**RESPONSE TO NOTICE OF DISAPPROVAL
TA-63 TRANSURANIC WASTE FACILITY
PERMIT MODIFICATION REQUEST, Rev. 1
LOS ALAMOS NATIONAL LABORATORY**

**RESPONSE TO THE
DISAPPROVAL, TA-63 TRANSURANIC WASTE FACILITY
PERMIT MODIFICATION REQUEST
REVISION 1.0
LOS ALAMOS NATIONAL LABORATORY
EPA ID# NM 0890010515
LANL-11-045**

This document responds to the May 24, 2012, New Mexico Environment Department-Hazardous Waste Bureau (NMED-HWB) Notice of Disapproval (NOD) referenced above. The NOD was issued for the *Permit Modification Request for Technical Area 63, Transuranic Waste Facility, Hazardous Waste Container Storage Unit* (PMR), Revision 1.0, submitted to NMED-HWB on April 16, 2012, by the United States Department of Energy and Los Alamos National Security, LLC, collectively the Permittees. The Permittees are seeking to modify the Hazardous Waste Facility Permit (Permit) for Los Alamos National Laboratory (LANL) for approval of the construction of the Transuranic Waste Facility (TWF) at Technical Area 63 (TA-63) and permission to store hazardous waste there.

Revised PMR Figure 2-5

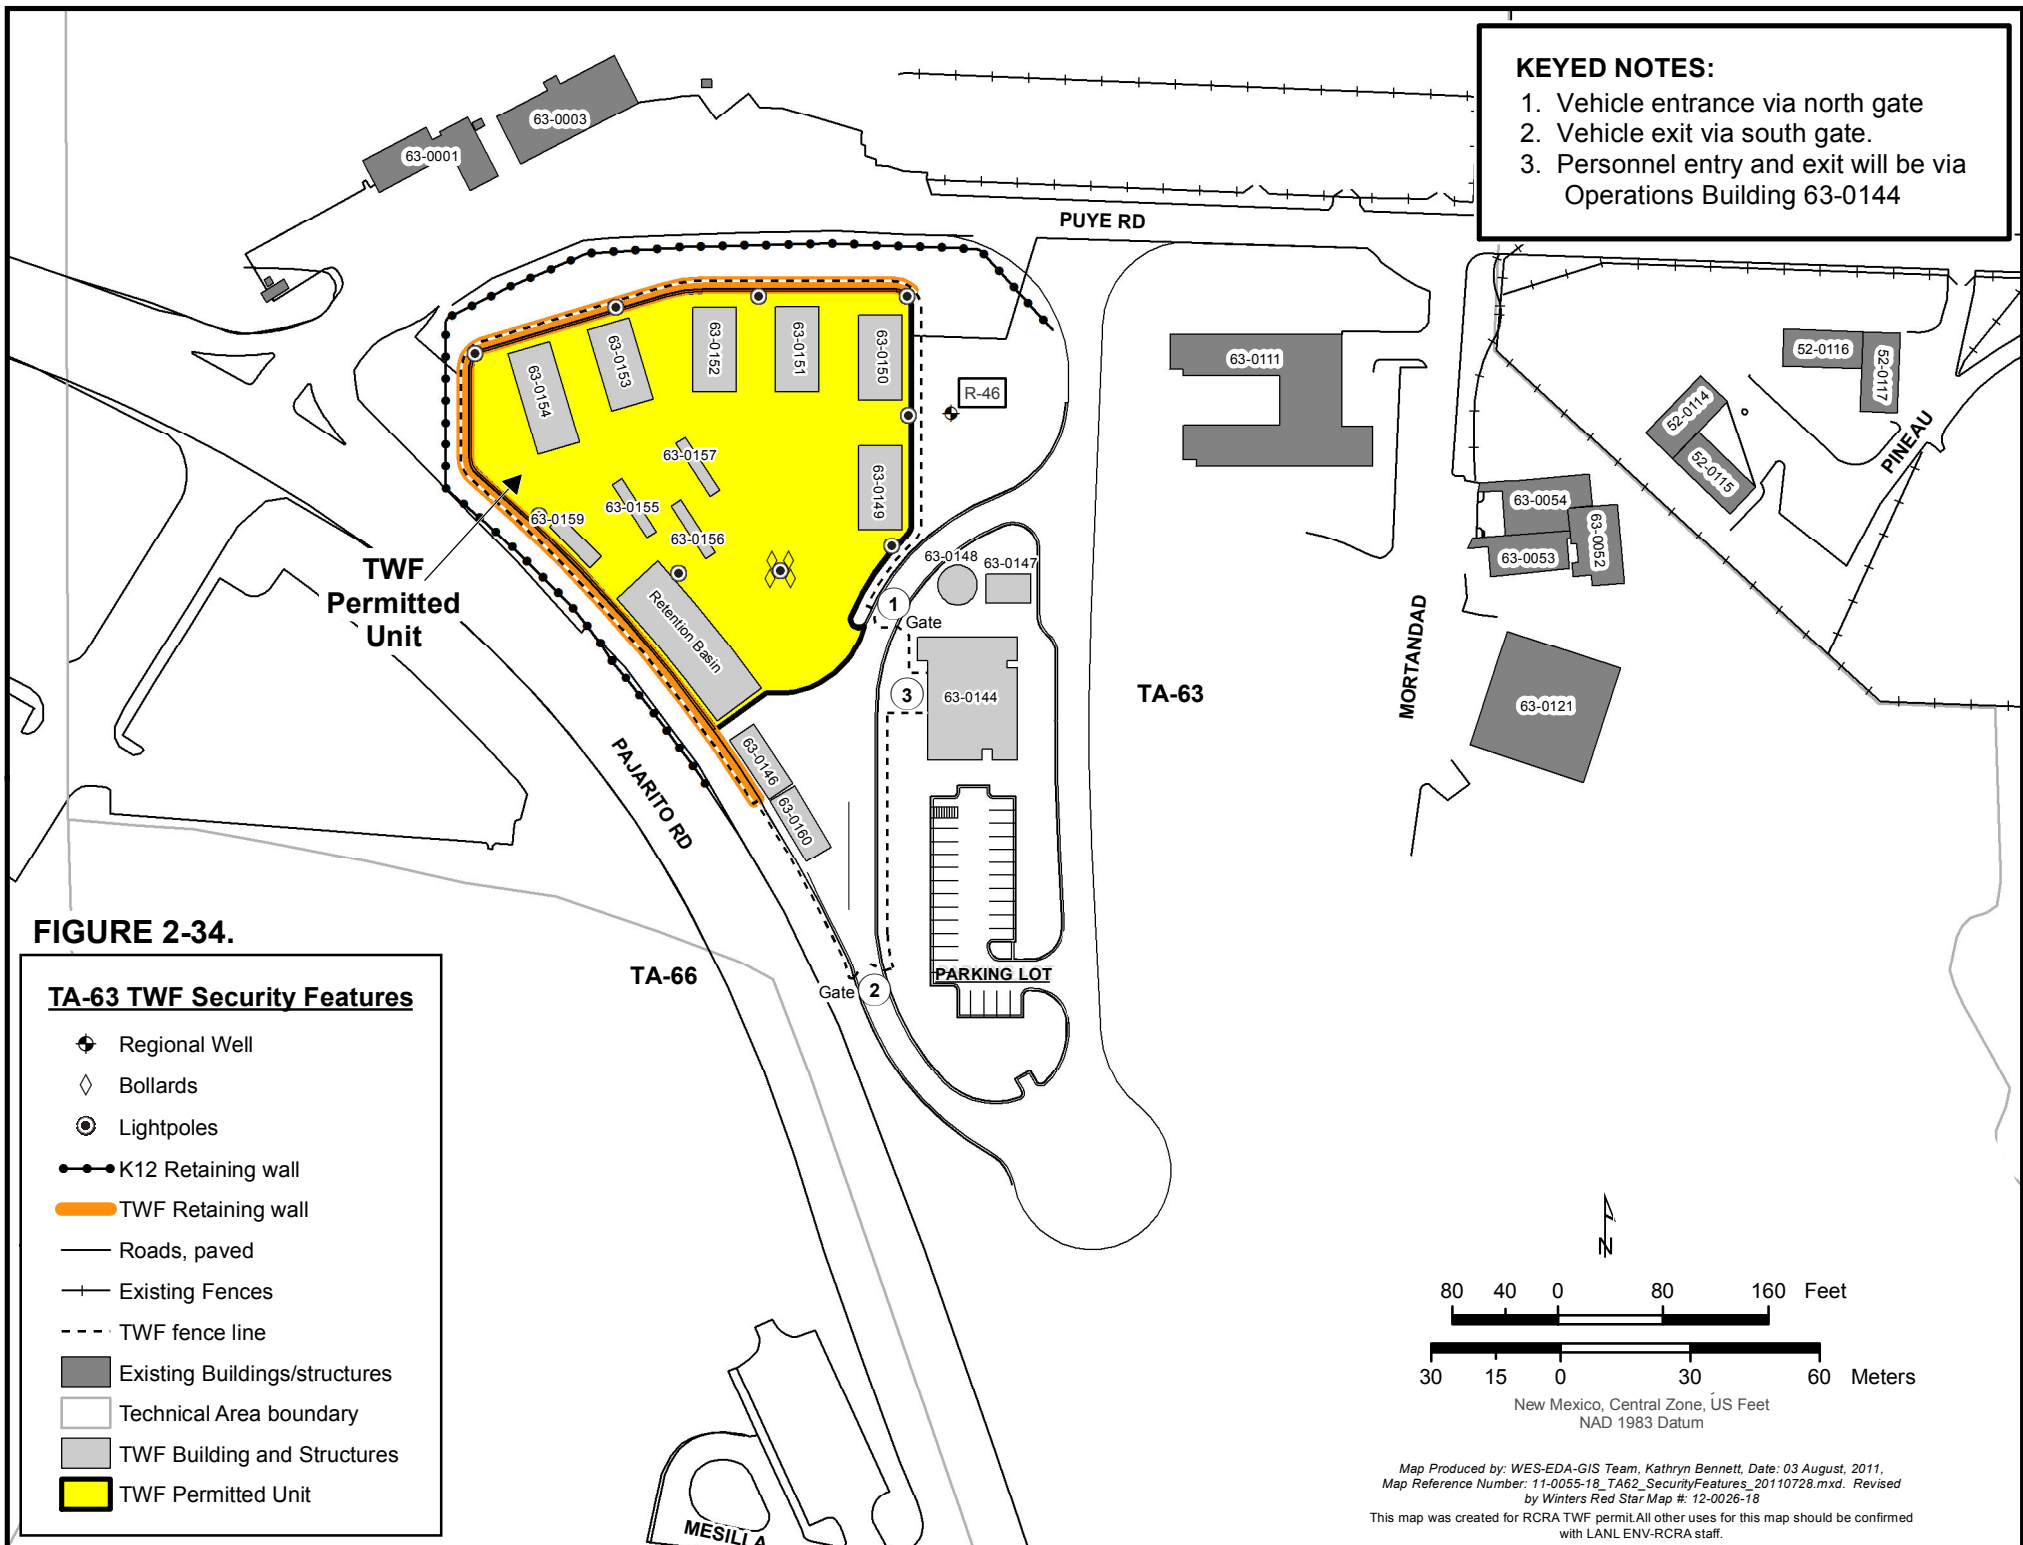
2. Section 2.2 still states that Figure 2-5 depicts "the location of areas where storage will occur highlighted," but the figure in fact does not have the storage areas highlighted. Revise the section to remove that statement, and instead refer to Figure 55 in Attachment G, Proposed Revisions to the LANL Hazardous Waste Facility Permit, and/or Figure F-1 of Attachment F, TA-63 Transuranic Waste Facility Closure Plan.

11. *Figure 2-5 indicates an "Area designated as future expansion," but there is no explanation of what this future expansion will be. Revise the PMR to discuss what type of future expansion (e.g., additional characterization trailers) the Permittees propose in Figure 2-5.*

Figure 2-5 has been revised to show the portions of the TWF where storage may occur and Section 2.2 has also been revised to reference Figure 55. The revised Figure 2-5 is included as Attachment C of this submittal.

Section 2.2.4 of the PMR has been revised by adding the following phrase to the description of additional characterization trailers to reference Figure 2-5: "Additional trailers may be needed as characterization needs for the facility change and would be located in the area noted (Note #13) for future expansion in Figure 2-5, Overall Site Plan".

Revised Permit Figure 55

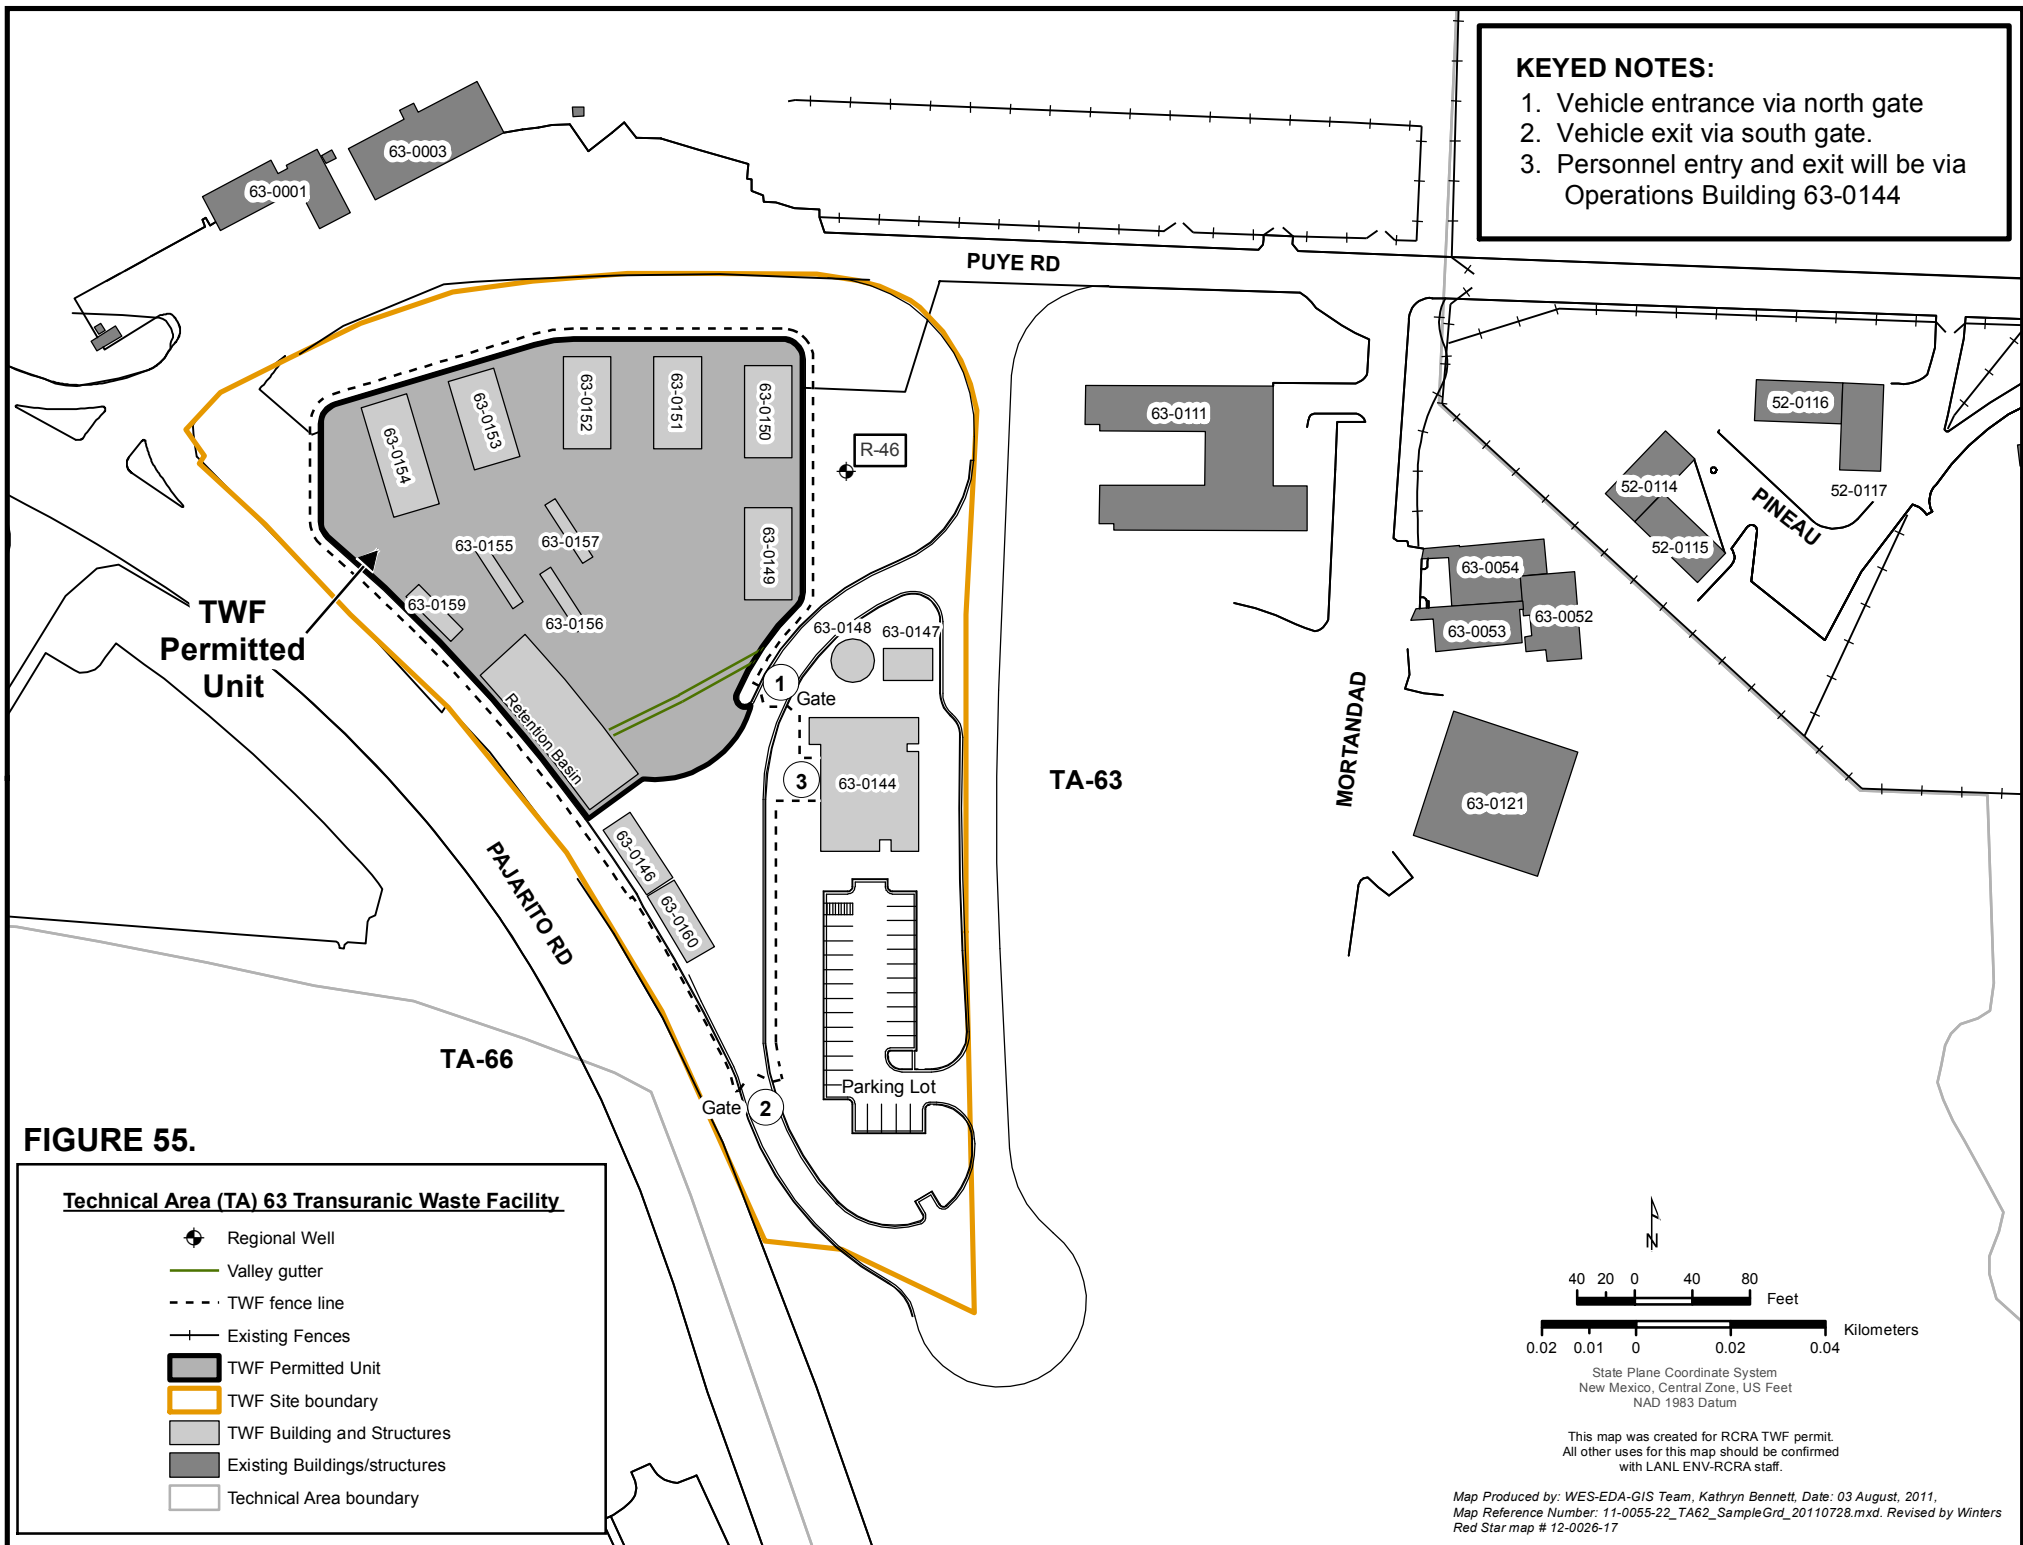
24. *Proposed Section 2.5 states that entry stations are shown in Figure 55; however, Figure 55 does not identify the entry stations. Revise the figure to include the locations of the entry stations.*

Figure 55 has been revised to include personnel access into the unit from the Operations Support Building. Revised Figure 55 is included in Attachment F of this document.
